TMI-2 PLANT MODIFICATIONS
FOR ACHIEVING COLD SHUTDOWN*

MAY 1979

TMI-2 PLANT MODIFICATIONS
FOR ACHIEVING COLD SHUTDOWN

Figure 1

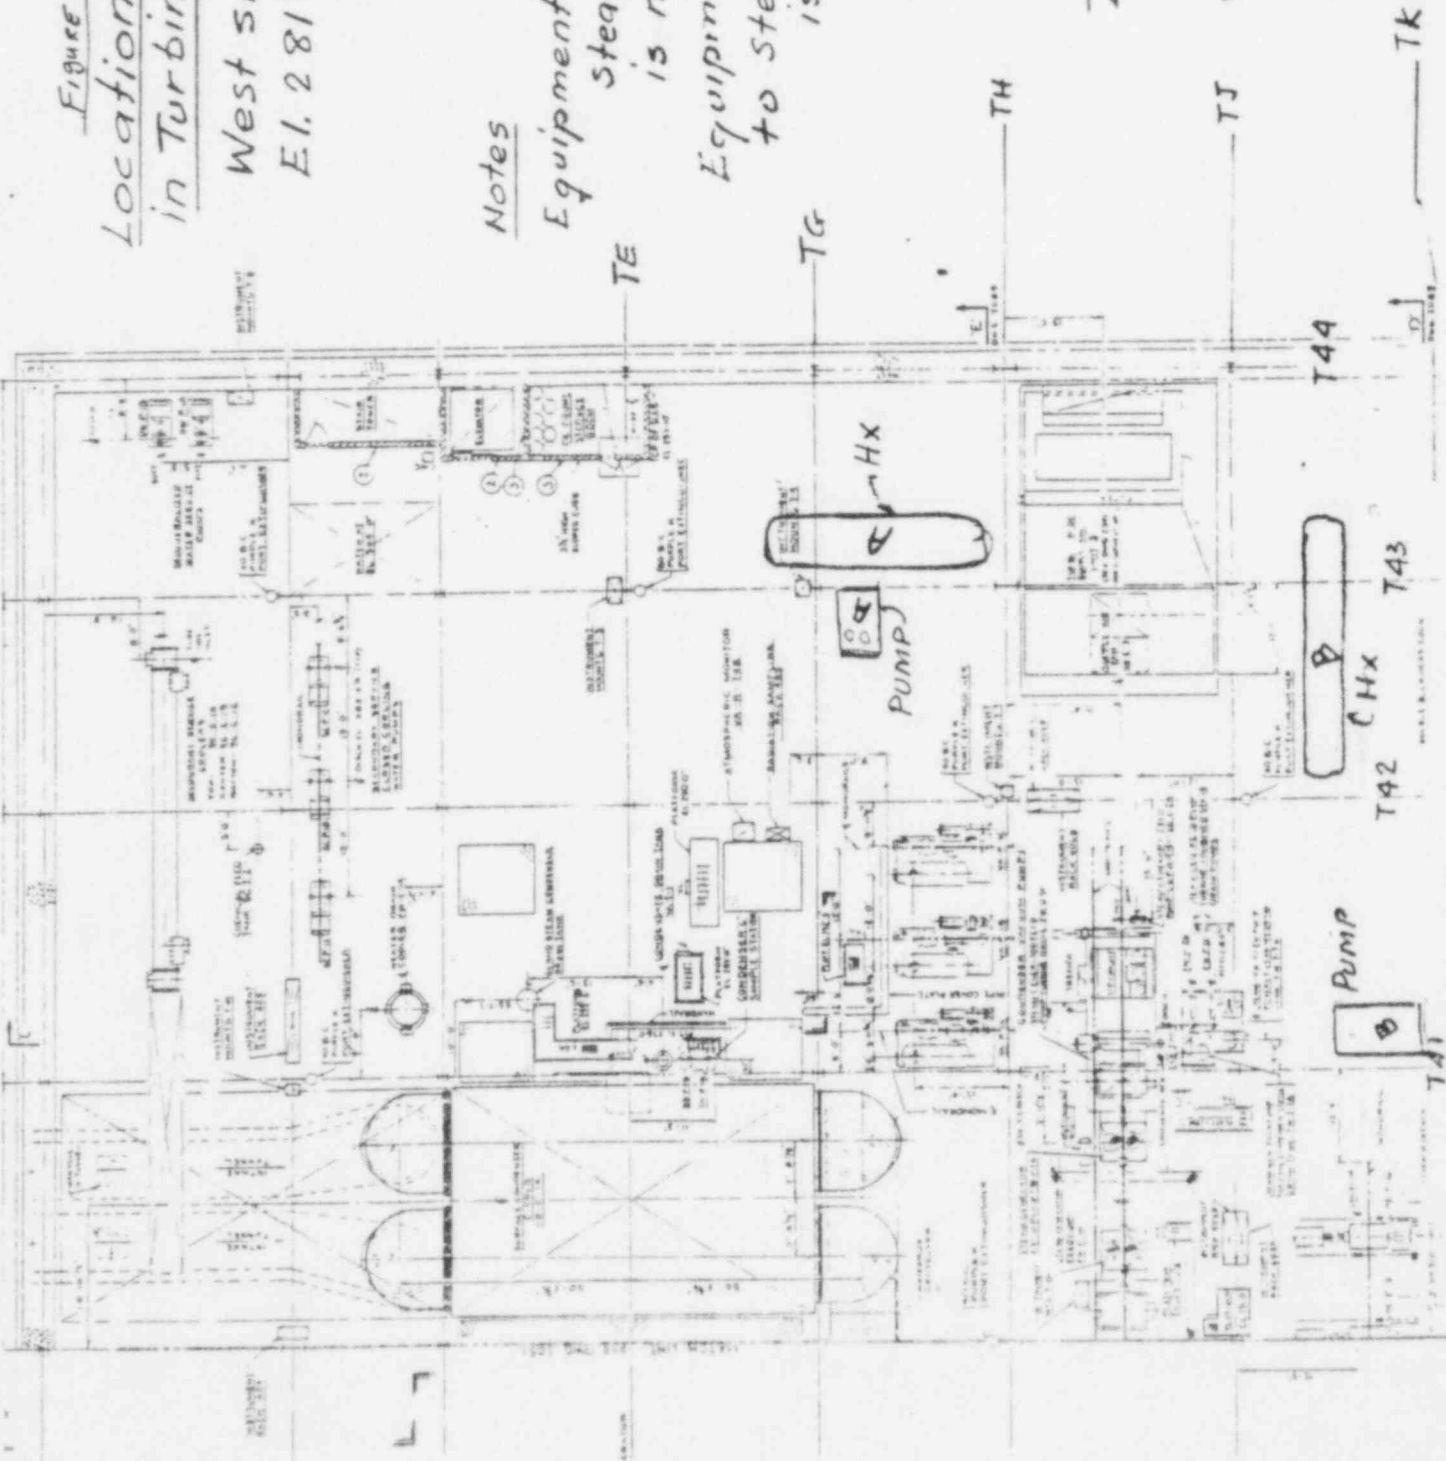
Modification of Steam Generator "A" and Steam Generator "B" involves installation of one pump and one heat exchanger for each steam generator. The new equipment will be installed in the north-west end of turbine building at elevation 281'-8", between column lines TJ and TK in north-south direction and T41 and T44 in east-west direction. The enclosed Figure 1 shows the general area of location of the above equipment.

Examination of the existing structural drawings of the turbine building area, where this equipment is to be installed, reveals that the base slab is four feet thick, with #11 rebars at 12 in. spacing, each way, top and bottom. Top of the structural concrete base mat is at the elev. 273'-0". The base mat is covered with a 3'-0" layer of lean concrete fill plus approximately 2 in. wearing surface, bringing the top elev. to 281'-8". Assuming 45 degree distribution of the load, and on the basis of the allowable concrete bearing pressure, the

licensee estimated that the maximum load that can be placed over one square foot of the area is 90 kips. Since the heaviest piece of equipment to be installed in this area is the heat exchanger, 135.8 kips, which when distributed over the area of the supporting saddles ($2 \times 4.67' \times .67' = 6.1 \text{ sq. ft}$) delivers the load to the floor of 22 kips, the licensee concluded that the slab is capable to support the load. The analysis was performed for the dead and live loads only, under static conditions.

We have concluded that the licensee has performed his analysis in accordance with the methods and procedures which are specified by the appropriate codes and standards. The use of these methods provide a reasonable assurance that the structural elements affected by this modification will perform their intended function.

Fig 2 (Sheet 1)

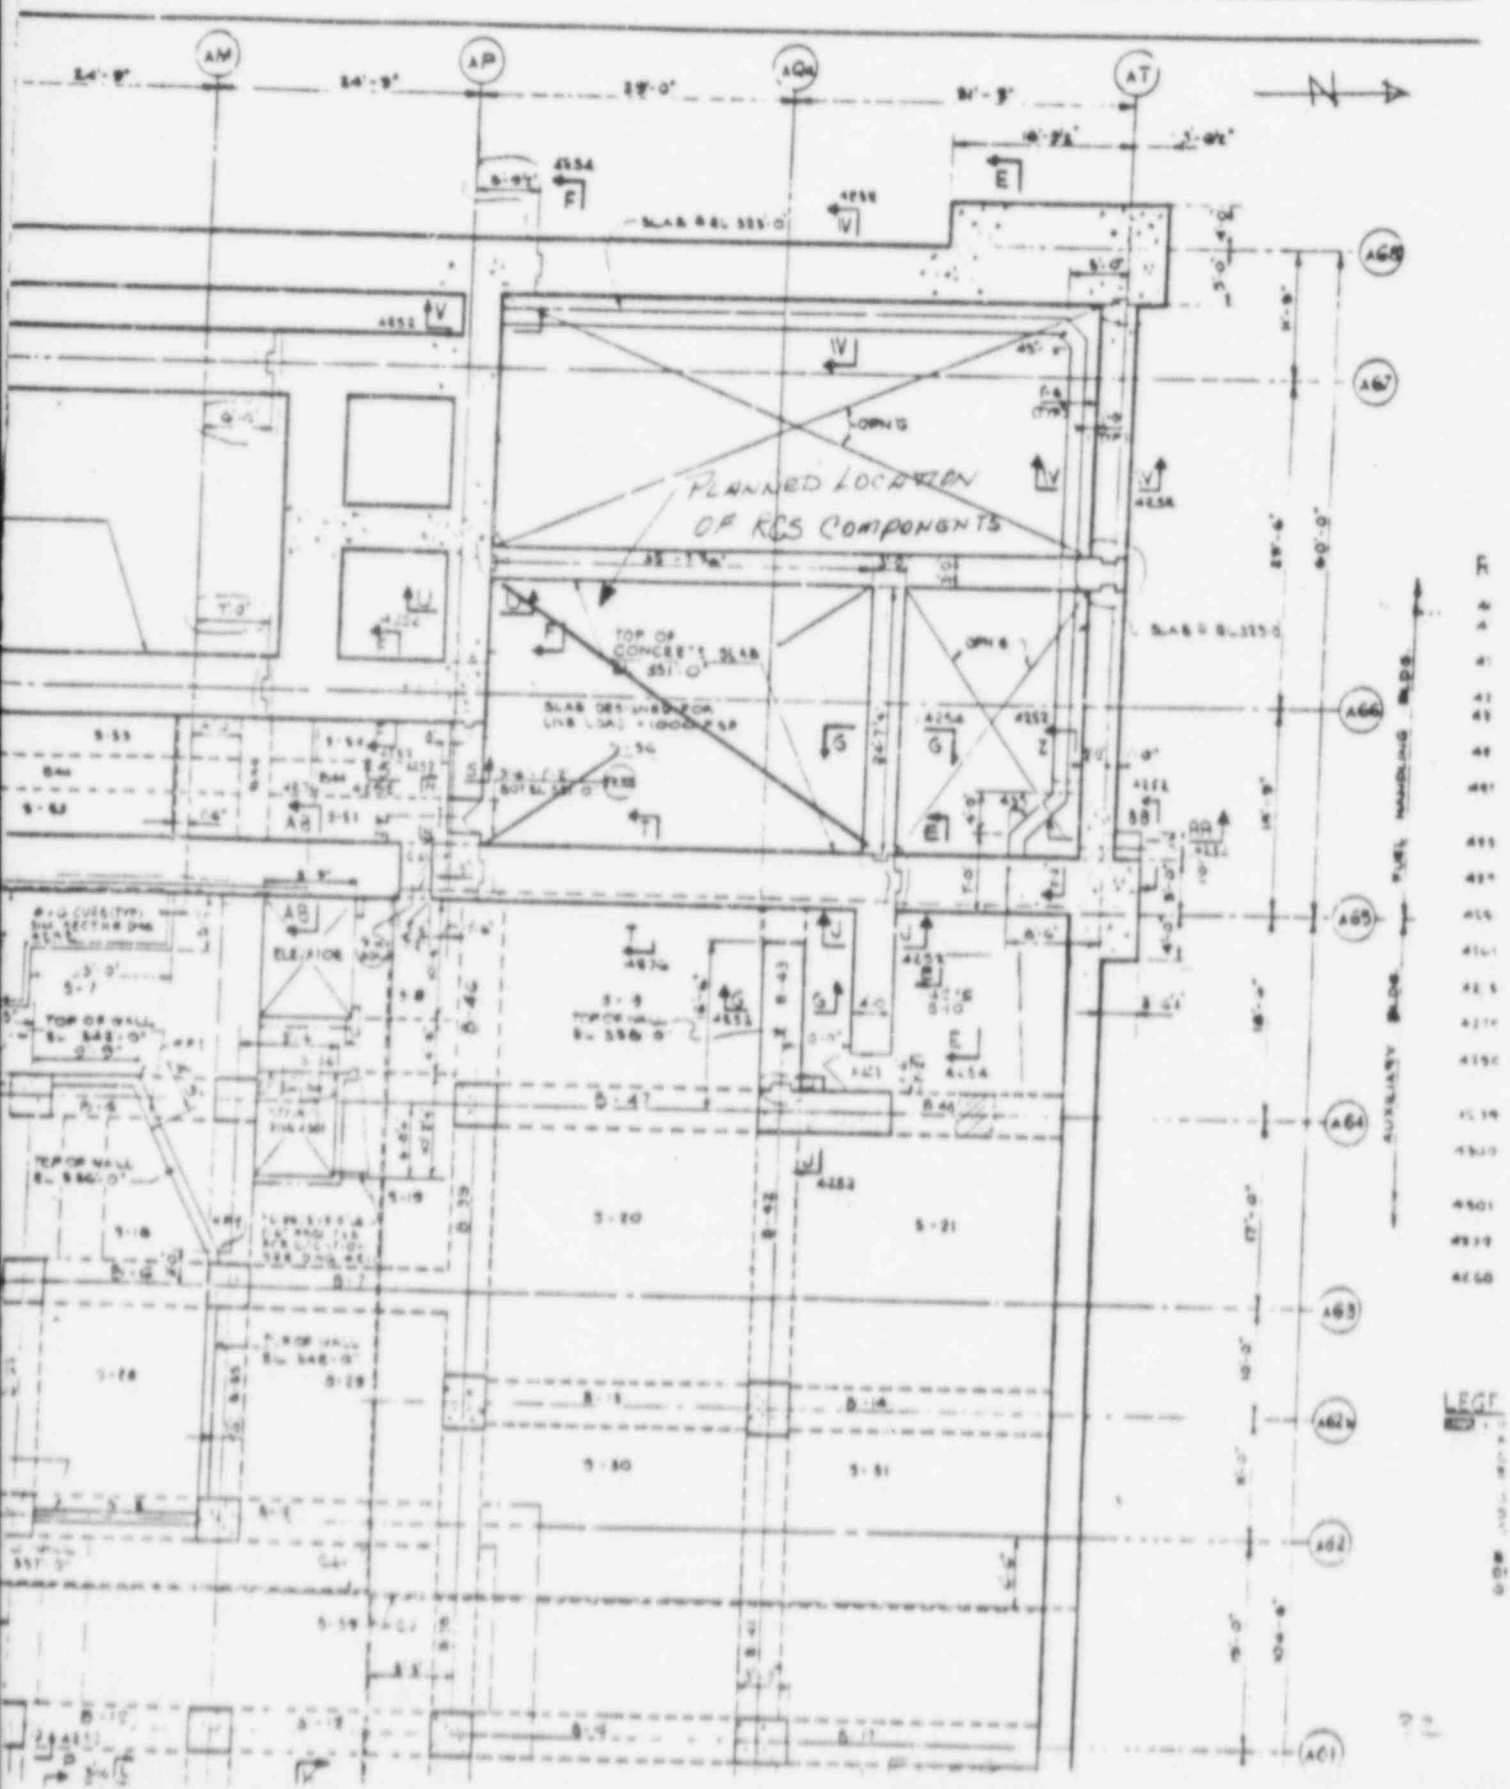
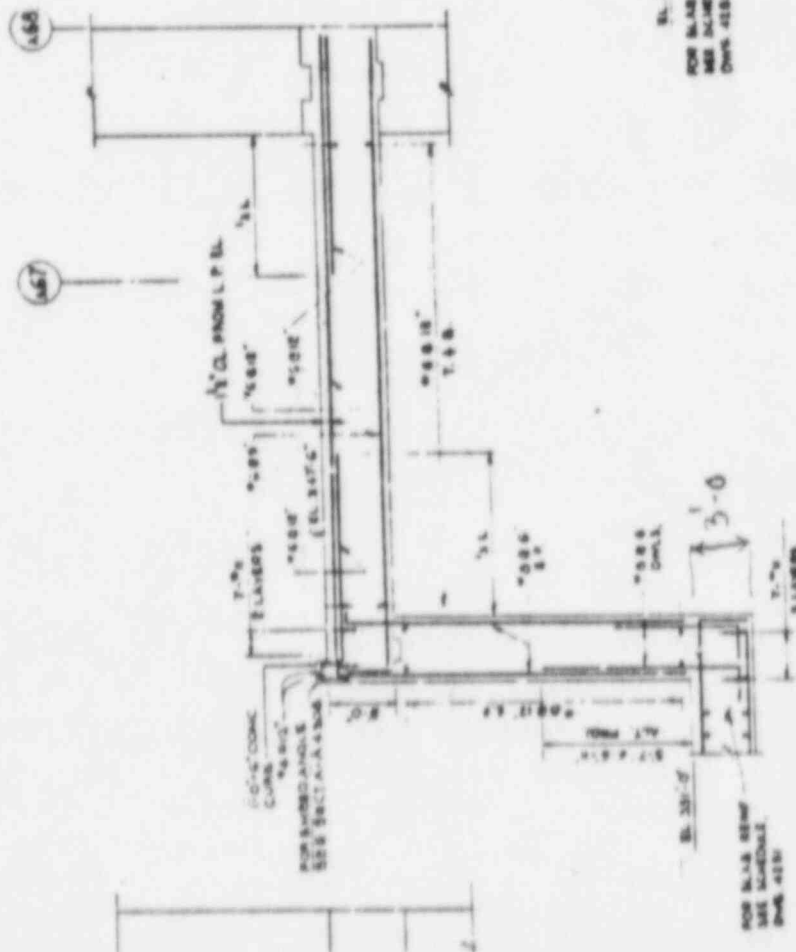
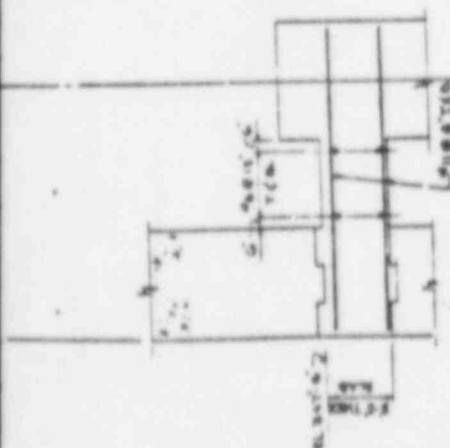
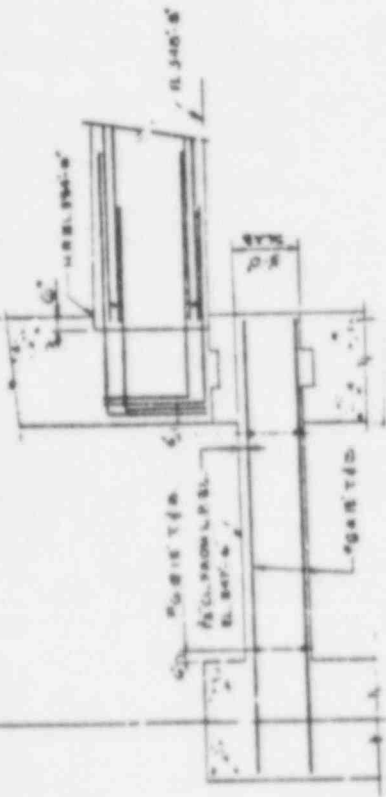
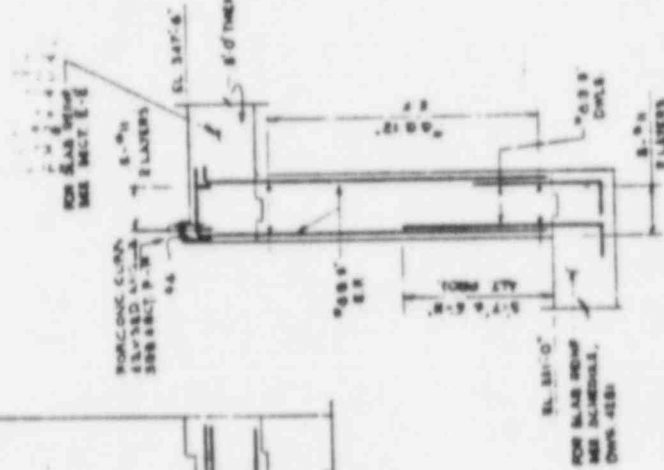
The enclosed Figure 2 (2 sheets) show the conditions of the original structure. The area is located between columns AP and AT in south-north direction and columns A65 and A67 in east-west direction. The slab is three feet thick and the reinforcing steel is #8 at 9 in. top and bottom in north-south direction and #8 at 6 in. top and bottom in the east-west direction. The compressive strength of the concrete is 3000 psi and the yield stress of the reinforcing steel is 60 ksi. The licensee has analyzed the slab for the additional loads resulting from the new equipment and concluded that the stresses will be within the allowables using generally accepted codes. The analysis was performed for the static conditions only. We conclude that the licensee has performed his analysis in accordance with the methods and procedures which are specified by the appropriate codes and standards. The use of these methods provide reasonable assurance that the structures affected by this modification will continue to perform their intended function.

FIGURE 3
Sketch Showing
Penetration through
Auxiliary Bldg Wall.

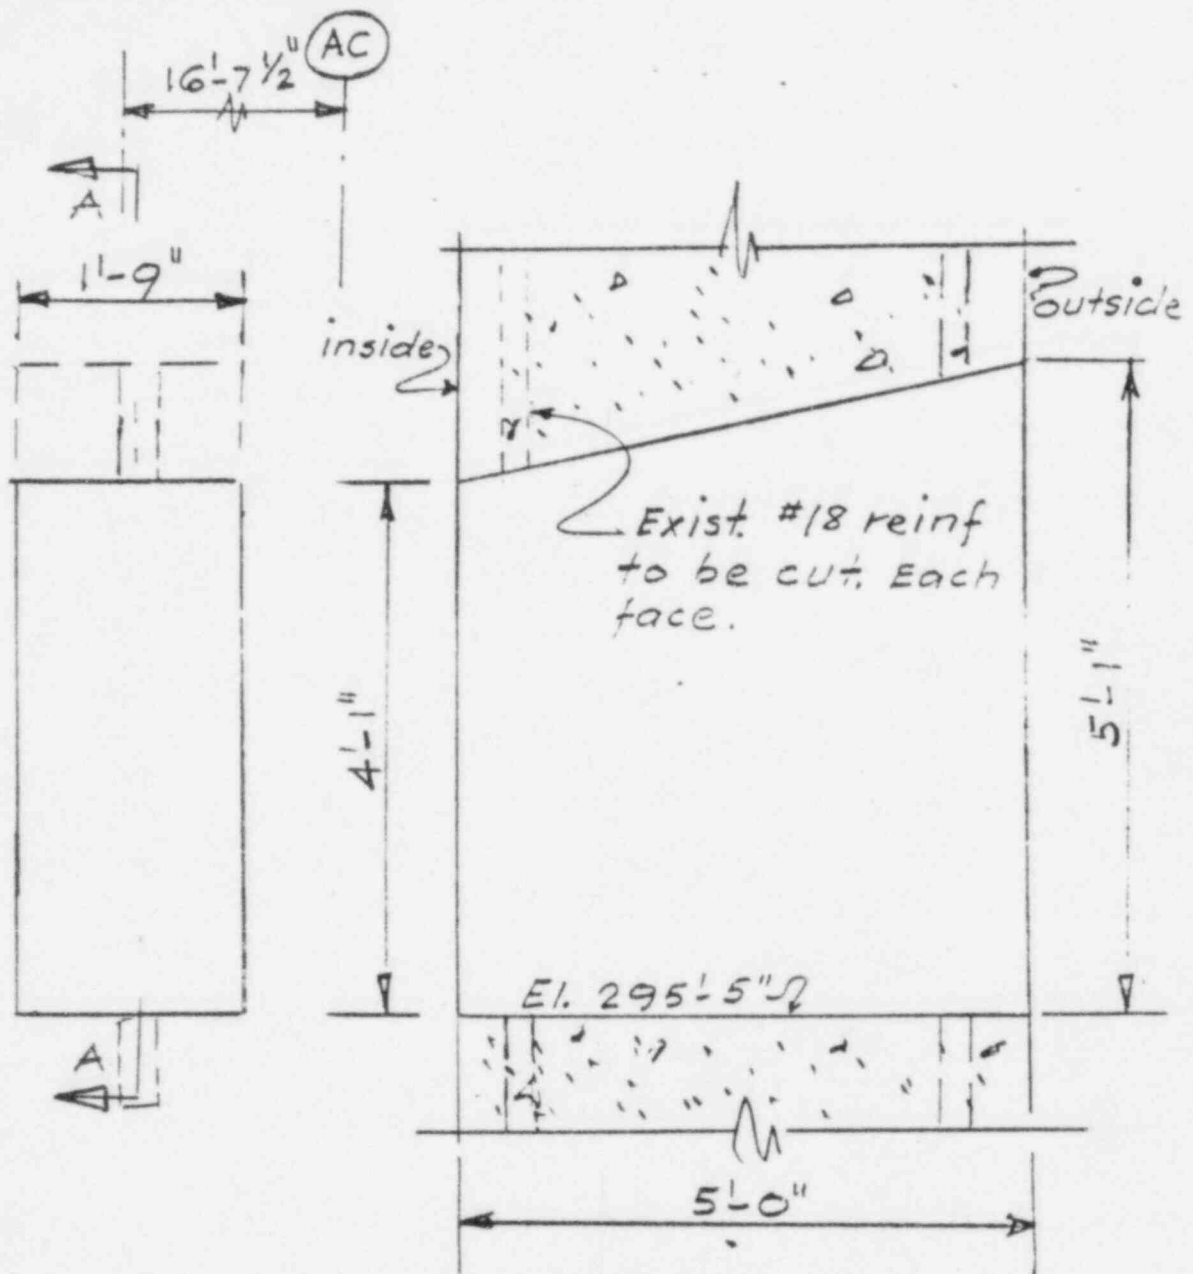
In order to provide the skid mounted decay heat removal system a penetration would have to be made through the west wall of the Fuel Handling Bldg., between column lines AC and AF and across column line A63, at elevation 297'-0" (See B&R Drawing 2075). This is approximately seven feet below grade. Excavation outside of the structure will be done by pick and shovel to minimize a possibility of damaging any piping or electrical conduit. The outside wall at that location is reinforced concrete, 5'0" thick. The compressive strength of concrete in this wall is 5000 psig.

The opening is to be made 21" wide 5'1" high on the outside tapering to 4'-1" at the inside face. One reinforcing bar, #18 is to be cut at each face. Figure 3 shows the front view and the cross-section at the opening.

At the time of writing of this report various methods of penetration are being studied. One possibility is using the oxygen lance process. A trial penetration is currently being performed by this method. Drilling through the well is also considered. The final method of the wall penetration will be described upon pending results of the test and consultation with the other experts in the field of construction materials.
